GROUP 54

CHASSIS ELECTRICAL

OUTLINE OF CHANGES

INSPECTION CHART FOR DIAGNOSIS CODES

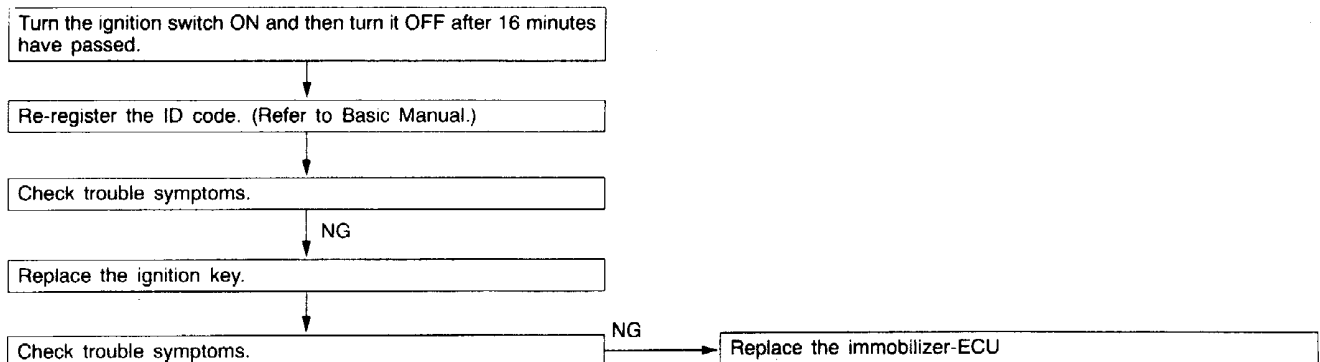
- The removal service point for the headlamp (L.H.) has been added to correspond to the addition of the diesel-powered vehicle.
Applicable models: 1900D <Vehicles with air conditioner>
- The troubleshooting for the immobilizer system has been added to correspond to the addition of the diesel-powered vehicle.
Applicable models: 1900D
- The following service procedures have been added to correspond to the addition of the 4-door sedan.
 1. Removal and installation of the rear combination lamp and rear lid lamp
 2. Removal and installation of the high-mounted stop lamp
 3. Removal and installation of the rear speakers
- The troubleshooting section has been changed to correspond to the addition of the diagnosis code No.33 to the immobilizer system.
Applicable models: Petrol-powered vehicles

Diagnosis code No.	Inspection items	Reference page
11*	Transponder communication system	-
12*	ID code are not the same or are not registered	-
21	Communication system between immobilizer-ECU and engine-ECU	-
31	EEPROM abnormality inside immobilizer-ECU	-
33*	Starting prevention system activated due to incorrect operation	54-2

Code No.33 Starting prevention system activated due to incorrect operation	Probable cause
If the transponder ID code mismatches five times in succession, this code will be output. This code can be canceled by turning the ignition switch ON, and then turning it OFF after 16 minutes have passed.	<ul style="list-style-type: none"> • Malfunction of the immobilizer-ECU • Malfunction of the transponder

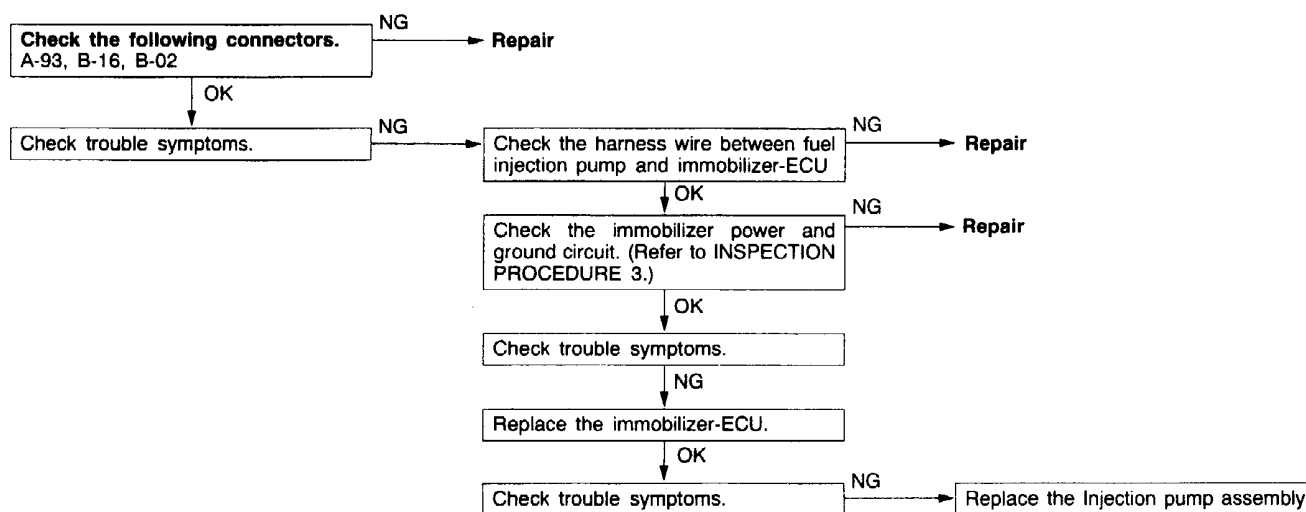
Code No.21 Communication system between immobilizer-ECU and fuel injection pump	Probable cause
After the ignition switch is turned to the ON position, the confirmation code is not received from the fuel injection pump within the allowable time, or an abnormal code is received.	<ul style="list-style-type: none"> ● Malfunction of harness or connector ● Malfunction of the fuel injection pump ● Malfunction of the immobilizer-ECU

Code No.33 Starting prevention system activated due to incorrect operation	Probable cause
---	-----------------------

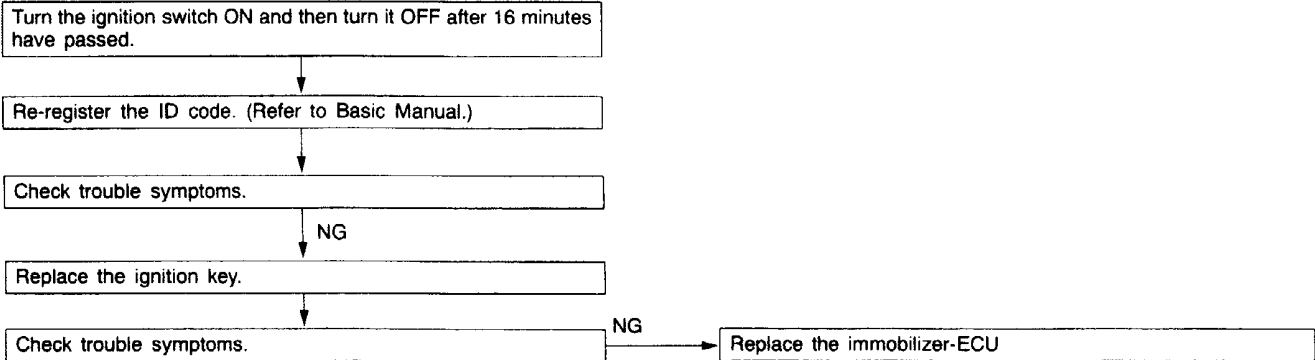
If the transponder ID code mismatches five times in succession, this code will be output. This code can be canceled by turning the ignition switch ON, and then turning it OFF after 16 minutes have passed.

- Malfunction of the immobilizer-ECU
- Malfunction of the transponder

Turn the ignition switch ON and then turn it OFF after 16 minutes have passed.

Re-register the ID code. (Refer to Basic Manual.)

Check trouble symptoms.

Replace the ignition key.

Replace the immobilizer-ECU
